**ALBERTA TRANSPORTATION SPRINGBANK OFF-STREAM RESERVOIR PROJECT
RESPONSE TO NRCB AND AEP SUPPLEMENTAL INFORMATION REQUEST 1, JULY 28, 2018**

Approvals
May 2019

9 APPROVALS

Distribution of ABWRET-E Wetland Values in the LAA Using the Alberta Merged Inventory (Version 4.1)

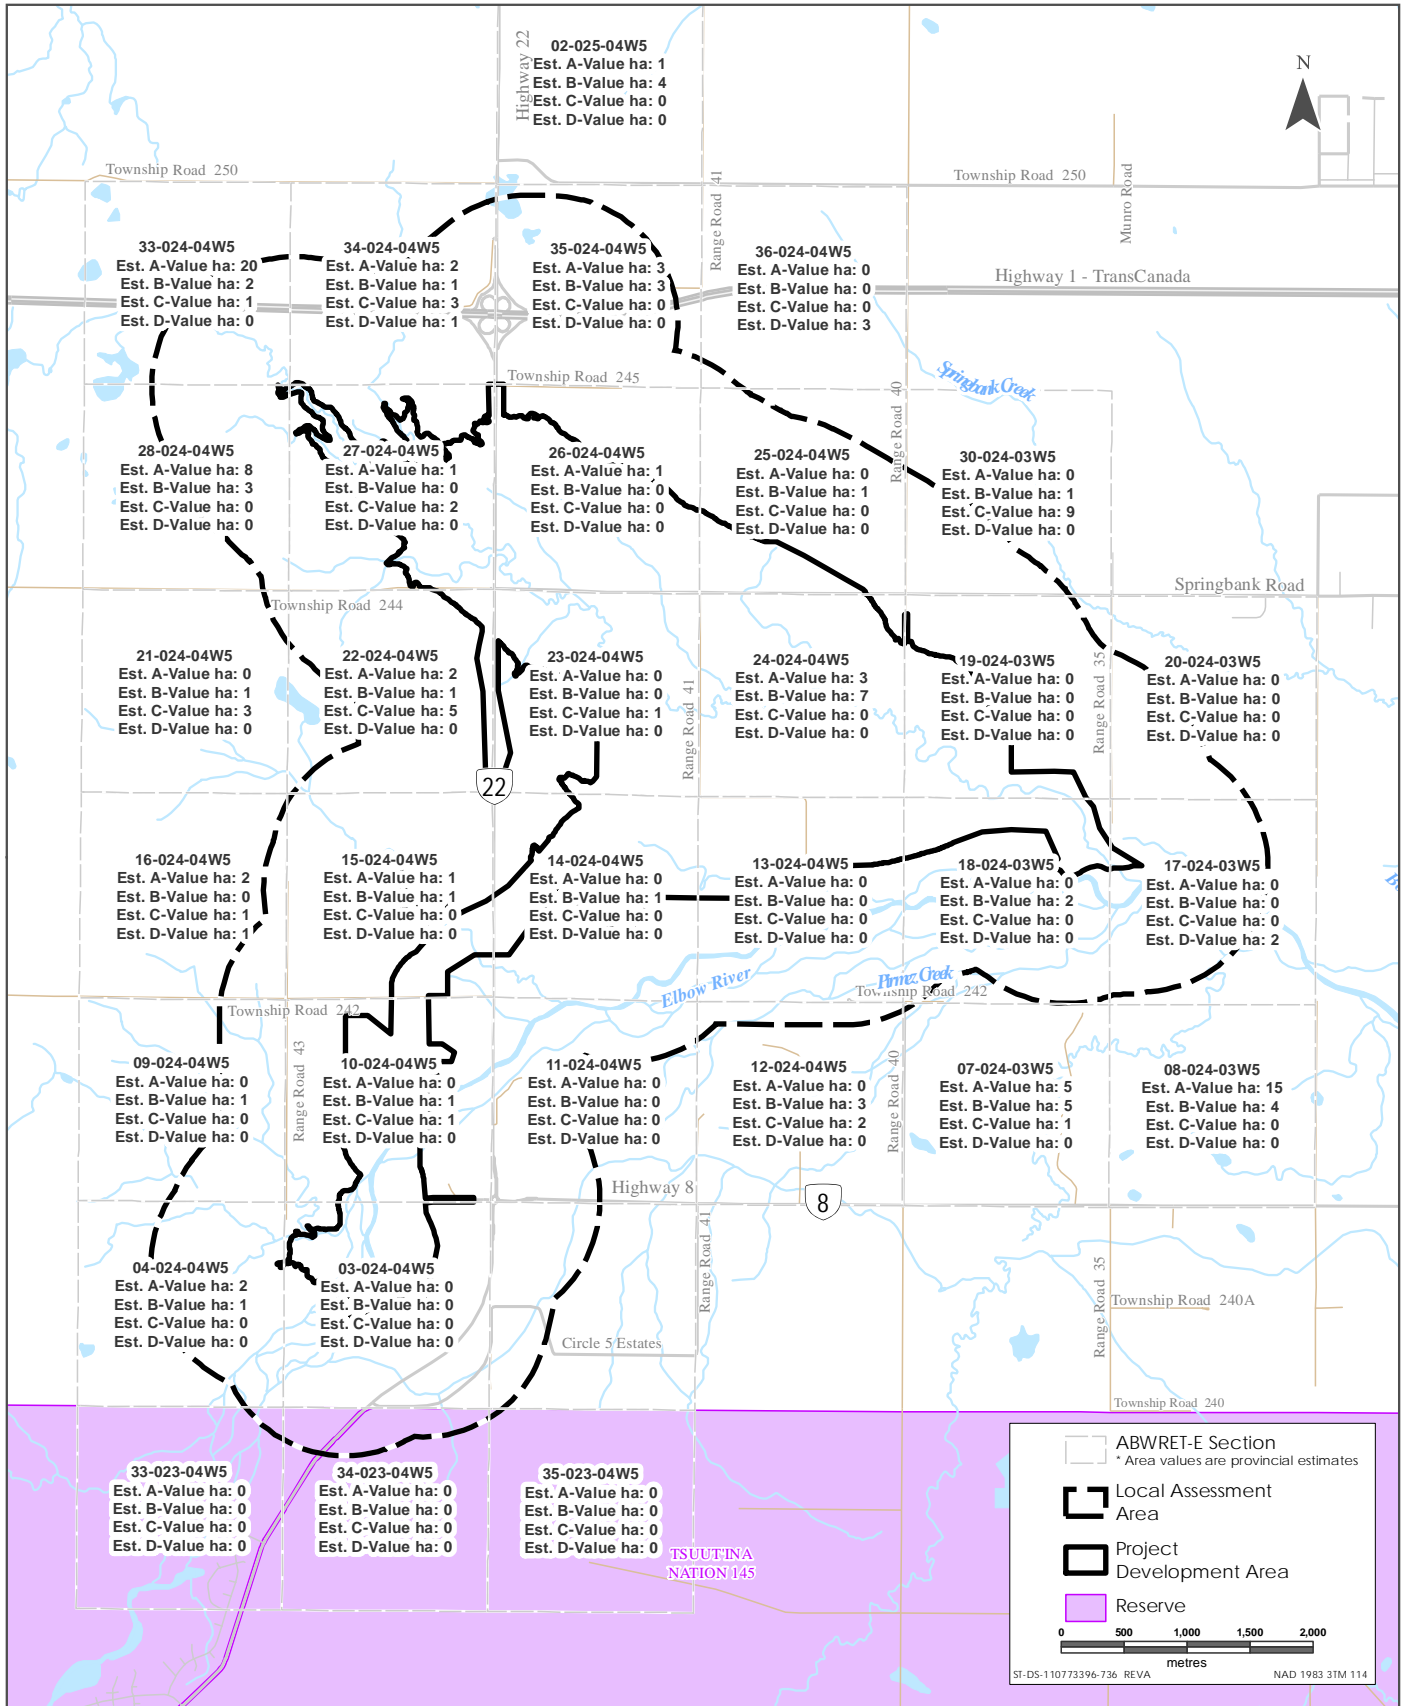
- a. The 108.2 ha of wetlands in the reservoir identified in Volume 3B, Table 10-11 did not appear to have a source and it is inconsistent with the 70.3 ha to be flooded as identified in Volume 3B, Table 10-8. Provide a breakdown of the wetland areas in the LAA, the reservoir, and the area of these wetlands that will be removed by construction and the wetlands that will be inundated by floodwater.
- b. Provide details on the wetland assessment method used to arrive at *estimated* values for wetlands and identify where the valued wetlands are located.

- b. The existing wetland area of 123 ha in the vegetation LAA identified in Volume 3A, Section 10.4.5, Table 10-13 was calculated using the Alberta Wetland Rapid Evaluation Tool – Estimator (ABWRET-E) (GoA 2015). That table provides an estimate of the area of wetlands by value class (A (highest) value, B value, C value and D (lowest) value) for wetlands captured within the Alberta Merged Wetland Inventory by Alberta Township System Version 4.1 for sections intersected by the vegetation LAA. The wetland areas shown in Volume 3B, Section 10.2.4, Table 10-12 (i.e., 15.3 ha) are calculated using the ABWRET-E Alberta Merged Wetland Inventory data, except for sections intersected by the PDA.

The estimated wetland values are summarized from GOA (2015). Wetland areas identified with this approach are not spatially explicit and are not directly comparable to wetland areas determined from Project mapping.

Figure IR530-1 shows the area of wetland value classes by section in the vegetation LAA.
